Our Ref: 1731/PJ/111214

11 December 2014

Re: Response to Office of Environment and Heritage, Department of the Environment and the Greater Blue Mountains World Heritage Advisory Committee Comments on the Tinda Creek Sand Extraction State Significant Development Proposal

FIGURE 1

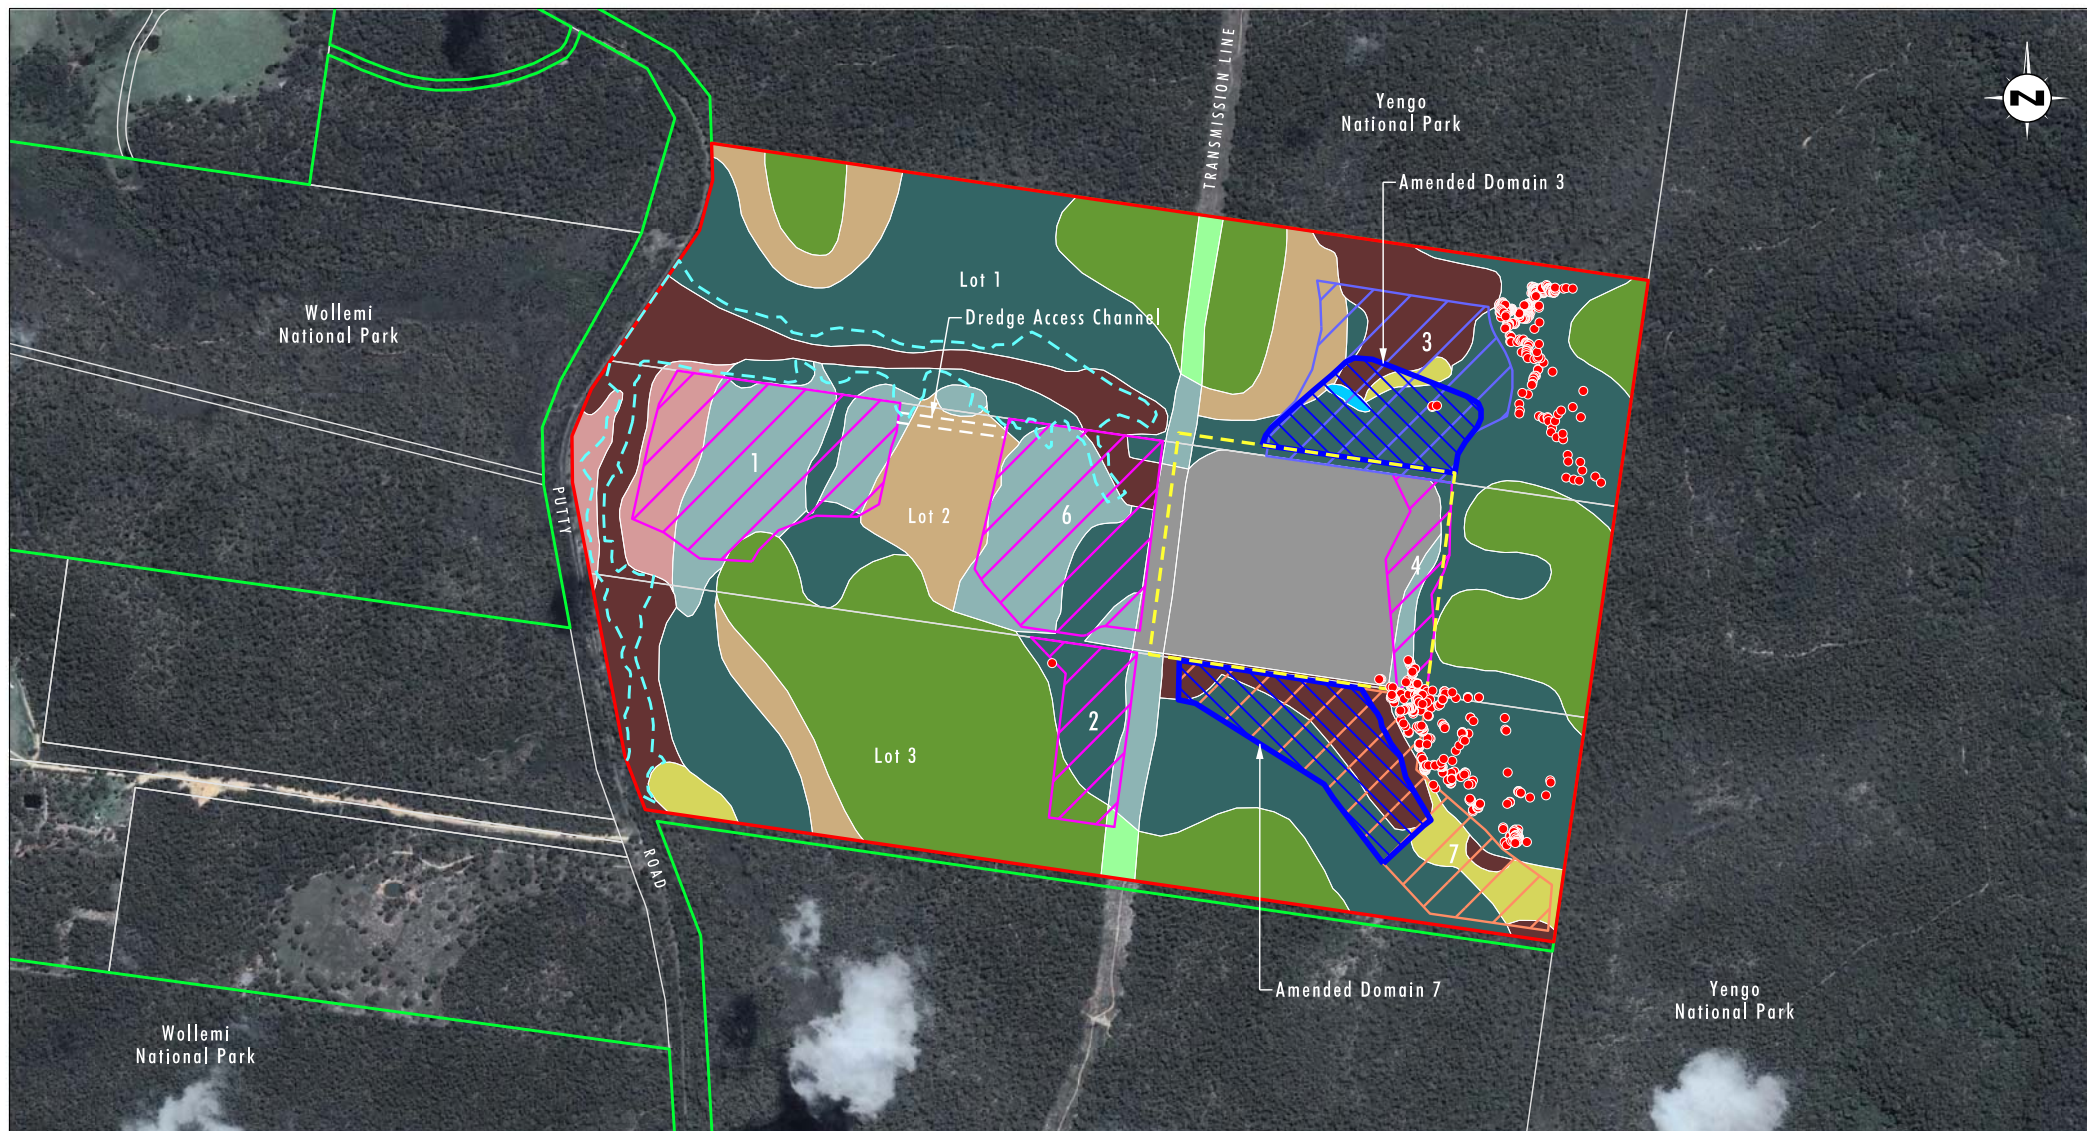
Further to our phone conversations, review of further submissions by Office of Environment and Heritage (OEH), Department of the Environment (DoE) and the Greater Blue Mountains World Heritage Advisory Committee (GBMWHAC) and meeting on 8 December 2014, we have further modified the proposed layout of extensions to Tinda Creek Sand Extraction area. As discussed at our meeting on 8 December 2014, these modifications further reduce potential impacts on high conservation value communities, threatened species and Yengo and Wollemi National Parks and Greater Blue Mountains World Heritage Area (GBMWhA).

The proposed changes to the quarry footprint are shown on **Figure 1** and include quarrying in approximately 6.1 hectares of Domain 3 that was disturbed during the November 2013 bushfire and approximately 8.2 hectares in Domain 7. The proposed quarry footprint in Domain 3 avoids the main population of *Grevillea parviflora* on Lot 1, however will disturb three of this species. Proposed quarrying within Domain 7 will avoid all *Grevillea parviflora* on Lot 3. The proposed 106 hectare on-site bio-diversity offset area contains 845 *Grevillea parviflora* individuals that will be protected in perpetuity.

The proposed quarry area on Domain 3 includes 4.6 hectares of Mellong Sandmass Dry Woodland, 0.2 hectares of water body, 0.3 hectares of Mellong Sandmass Sedgeland, 0.7 hectares of Mellong Sandmass Swamp Woodland and 0.3 hectares of Stringybark – Ironbark forest.

The proposed quarry area on Domain 7 avoids the Mellong Sandmass Sedgeland at the eastern end of Domain 7 and includes 4.2 hectares of Mellong Sandmass Swamp Woodland and 4.0 hectares of hectares of Mellong Sandmass Dry Woodland. The proposed Domain 7 quarry footprint has been designed to avoid disturbance of *Grevillea parviflora* subsp. *parviflora* on the northern boundary and provide a 40 metre buffer to known locations of this species.

The proposed modifications to the quarry footprint increase the buffer distance between quarrying and GBMWhA to be in excess of 230 metres along the northern boundary of the proposed Domain 3 quarry area and in excess of 270 metres to the eastern edge of the proposed Domain 7 quarry area. A buffer of in excess of 100 metres is also provided between quarrying and Yengo National Park to the south.

FIGURE 5

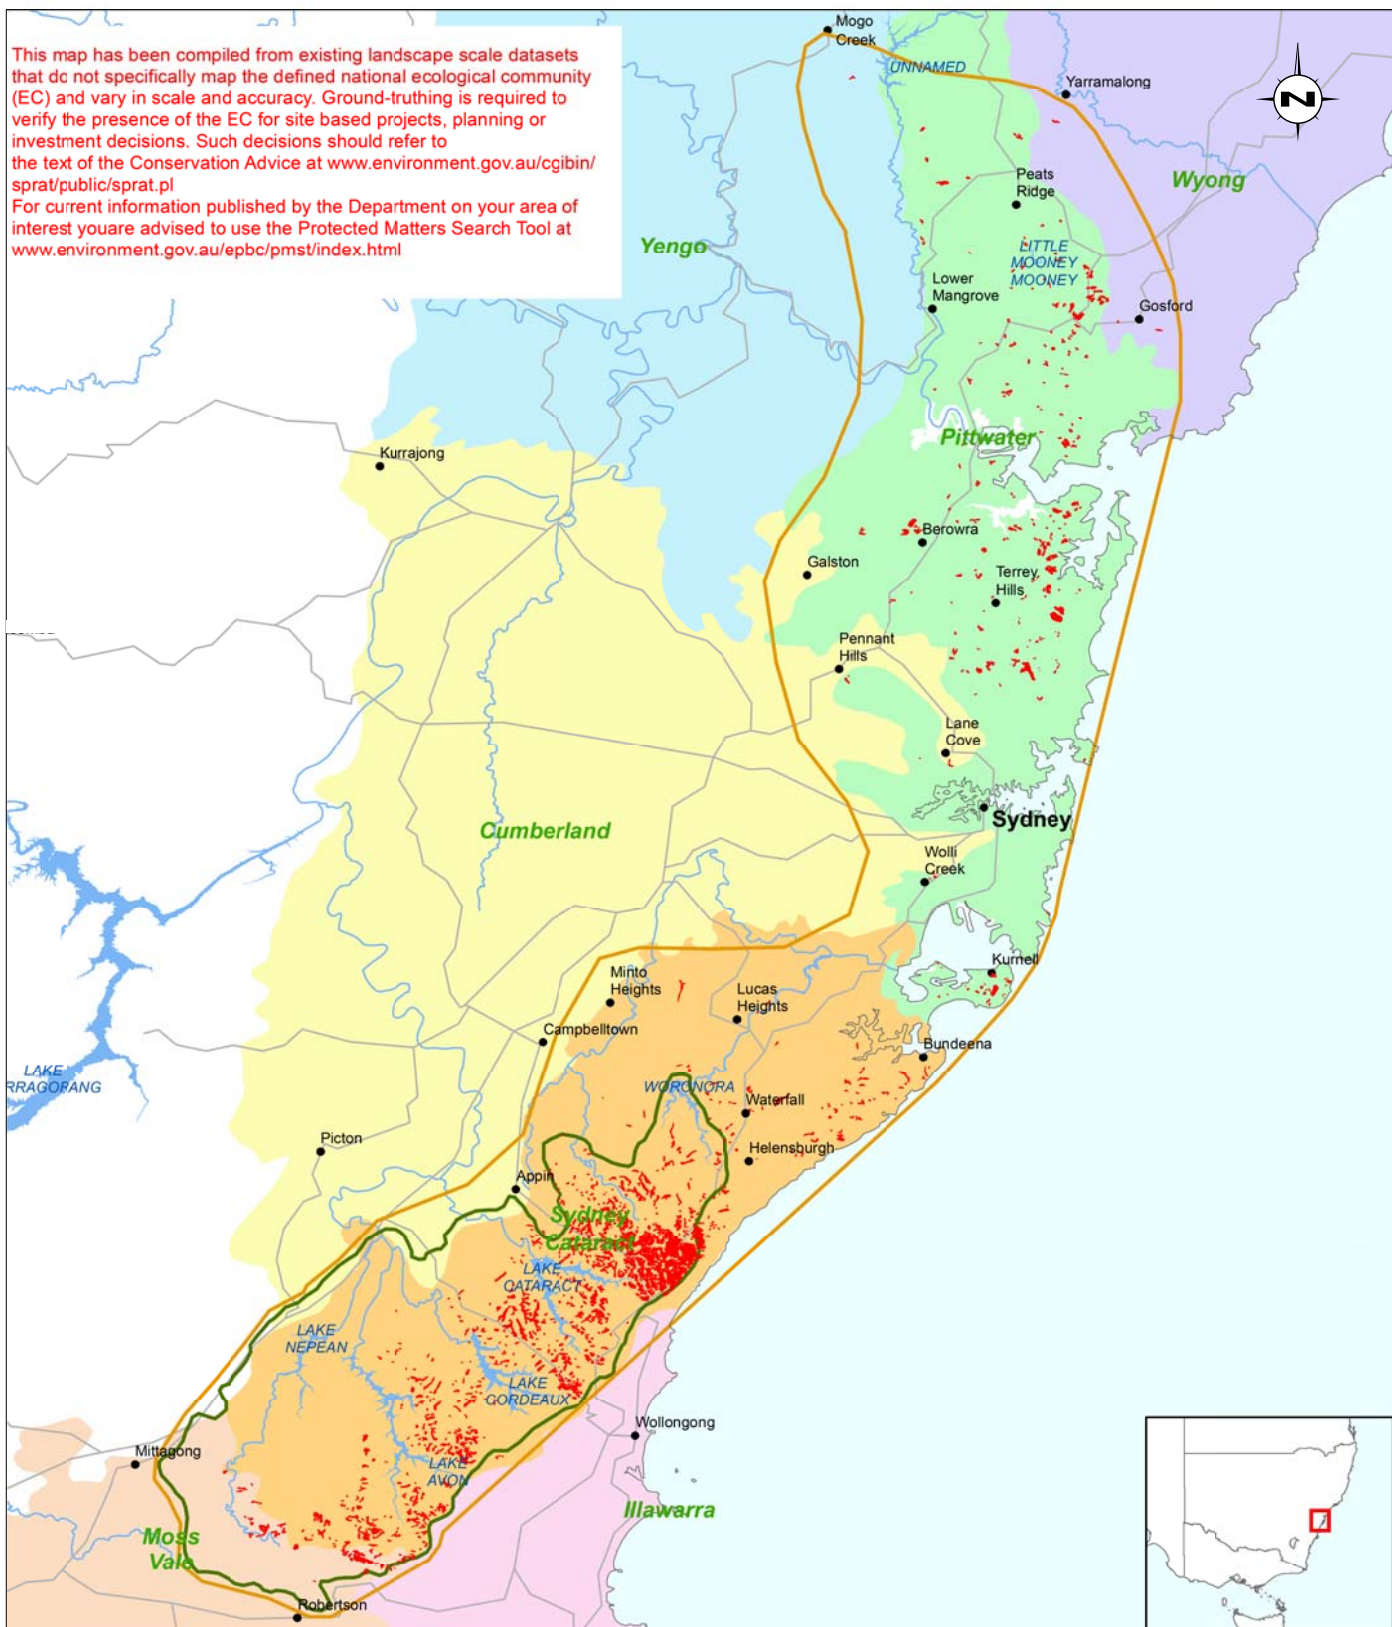
OEH contends that the Response to Submissions report does not convincingly demonstrate that the Mellong Sandmass Sedgeland community recorded in the Project area is not Coastal Upland Swamp EEC. Mellong

The Mellong Sandmass Sedgeland within the Project area shares some floristic similarities with the Coastal Upland Swamp EEC (14% species in common with the Final Determination species list), the Scientific Committee determination states that the EEC occurs as far west as the Great North Road in Yengo National Park, which occurs to the east of the Project area. The Commonwealth DoE has recently listed Coastal Upland Swamps under the *Environment Protection and Biodiversity Conservation Act 1999* (EPBC Act) and include mapping of areas within the Sydney Basin that are *likely* and *may* contain Coastal Upland Swamps (refer to **Figure 5**). The Project area is located well outside this predicted extent, which further supports the assertion that the community occurs where rainfall exceeds 950 millimetres per year. The coastal environments with rainfall exceeding 950 millimetres per year allows for the development of highly diverse swamp communities, as opposed to the much more depauperate Mellong Sandmass Sedgeland which has 14% of flora species in common with the final determination at both the state and Commonwealth level.

FIGURE 6

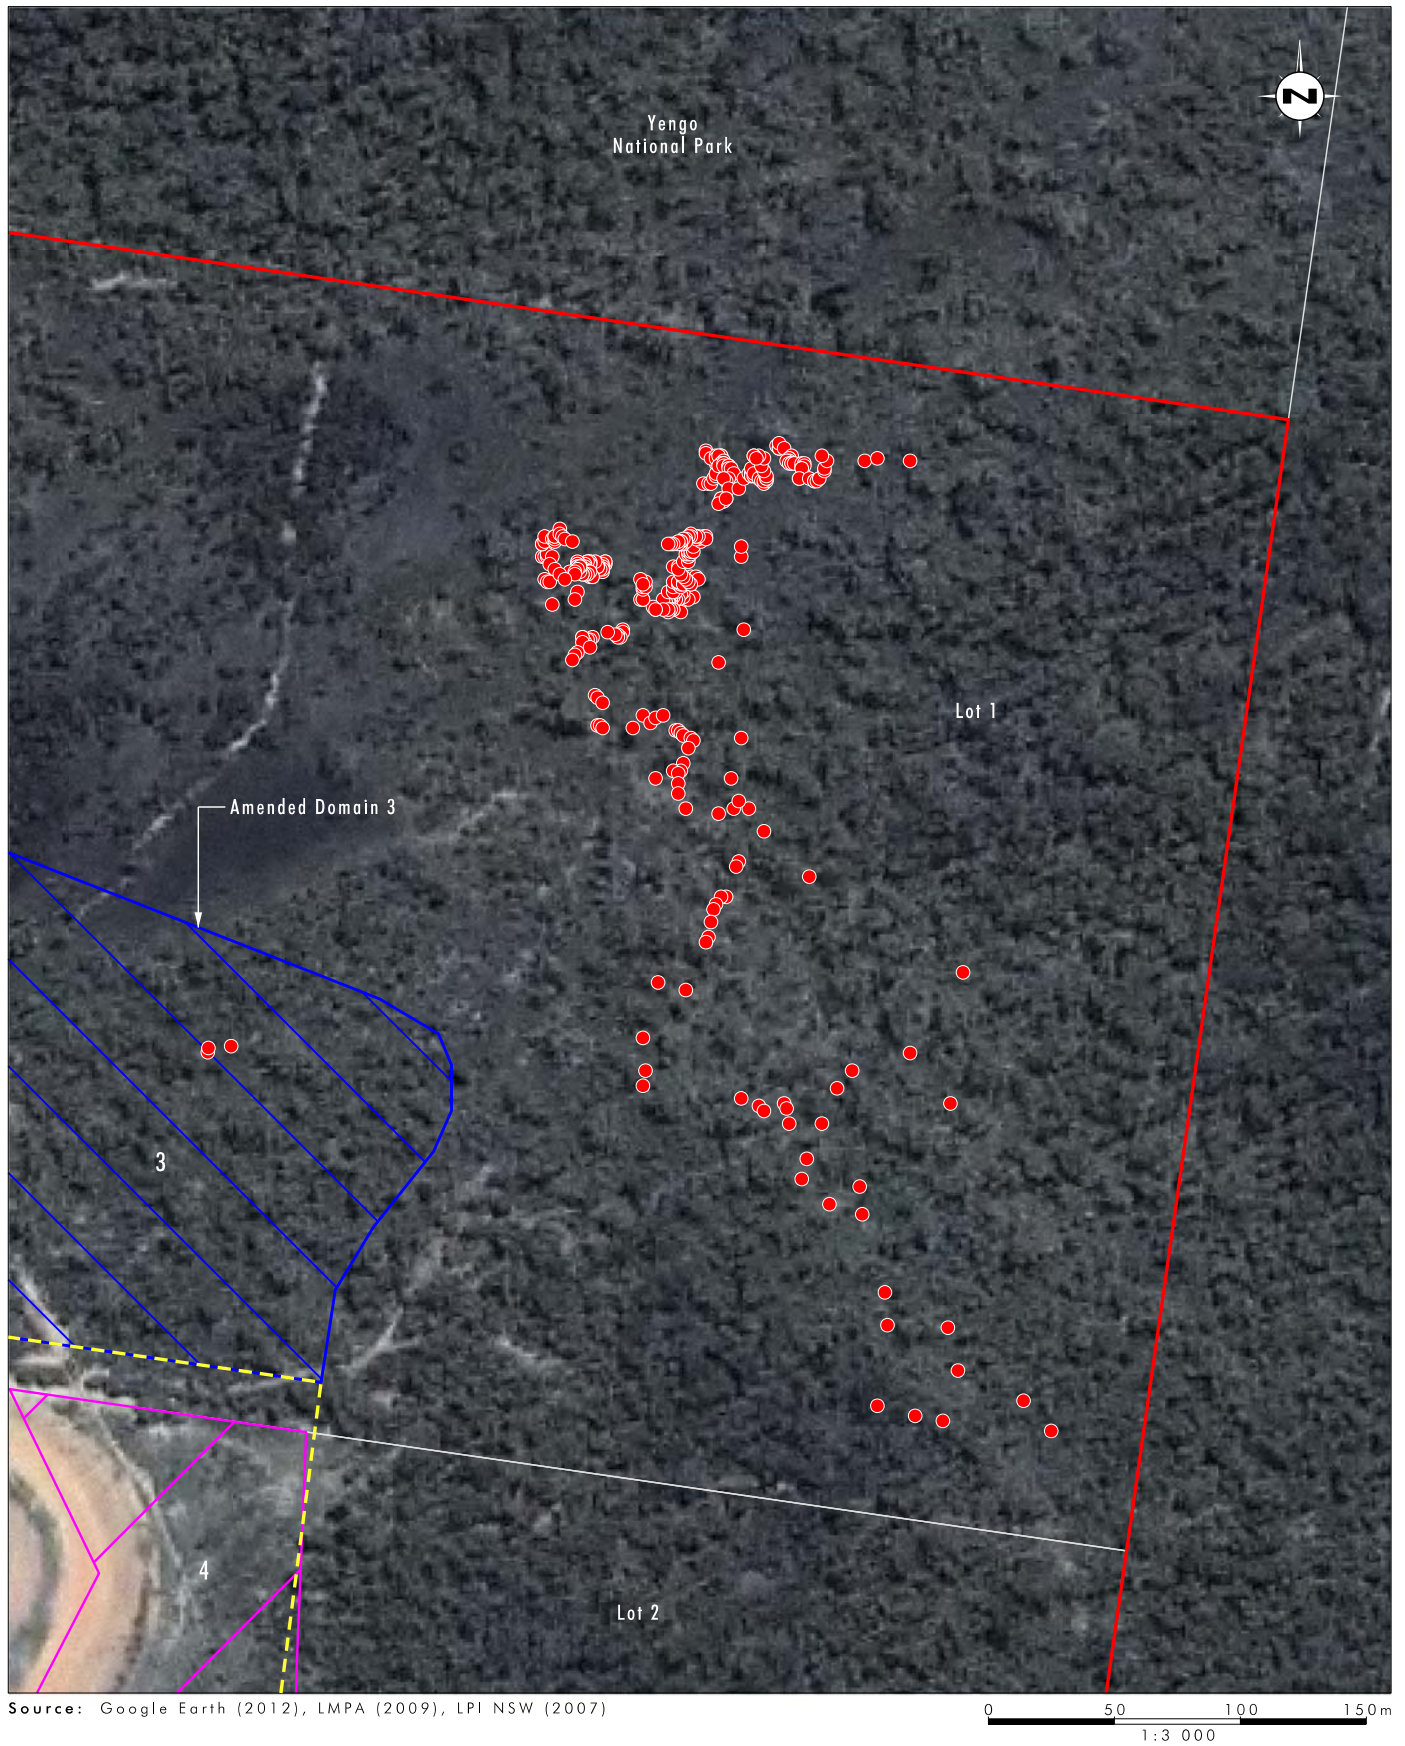
1. The Department notes that the proponent has revised impact area for the domain 3 option to substantially reduce the impact to the Small-flower Grevillea, compared to the impact proposed in the original referral. The Department requests that the proponent provide a discussion of avoidance measures considered for the domain 7 option.	Since exhibition of the Project and in response to concerns from OEH and the DoE, the proponent has reduced the impact on <i>Grevillea parviflora</i> subsp. <i>parviflora</i> further (refer to Figures 6 and 7). The revised quarry plan avoids all but three (3) known records of <i>Grevillea parviflora</i> subsp. <i>parviflora</i> and has implemented a minimum 40 metre buffer zone between the proposed extraction area and the closest known records of <i>Grevillea parviflora</i> subsp. <i>parviflora</i> to minimise the potential for indirect impacts. The avoidance of impacts will ensure that <i>Grevillea parviflora</i> subsp. <i>parviflora</i> will not be adversely impacted as a result of the Project.

2. The Department requests that further information be provided regarding the possibility of indirect impacts on <i>Grevillea parviflora</i>. Specifically, the Department requests information on: a) The proximity of individuals to existing quarrying activity (while this information has been presented graphically (Figure 4.2 of Ecological Assessment), it is difficult to judge the distance precisely. A higher resolution map is requested, together with a text description. b) The distance between quarrying activities and individuals proposed if Domain 3 is quarried. c) Any additional information that would aid in assessing indirect impacts on the species.	Since exhibition of the Project and in response to concerns from OEH and the DoE, the proponent has reduced the impact on <i>Grevillea parviflora</i> subsp. <i>parviflora</i> further (refer to Figures 6 and 7). The revised Project avoids all known records of <i>Grevillea parviflora</i> subsp. <i>parviflora</i> except for three (3) within Domain 3 and has implemented a minimum 40 metre buffer zone between the proposed extraction area and the closest known records of <i>Grevillea parviflora</i> subsp. <i>parviflora</i>. Further clarification is provided in relation to the possibility of indirect impacts on <i>Grevillea parviflora</i> subsp. <i>parviflora</i>: A minimum 40 metre buffer zone between proposed extraction in Domains 3 and 7 and the closest known records of <i>Grevillea parviflora</i> subsp. <i>parviflora</i>. This buffer zone has been increased from 10 metres to 40 metres. The boundary of the proposed extraction area will be demarcated to prevent unauthorised access to the buffer zones and biodiversity offset areas. Access to the buffer zones and biodiversity offset areas will be limited to actions related to the ongoing management and monitoring of the site and for any corrective actions such as weed management or feral animal control. Restriction of access to these areas will reduce the likelihood of indirect impacts occurring.
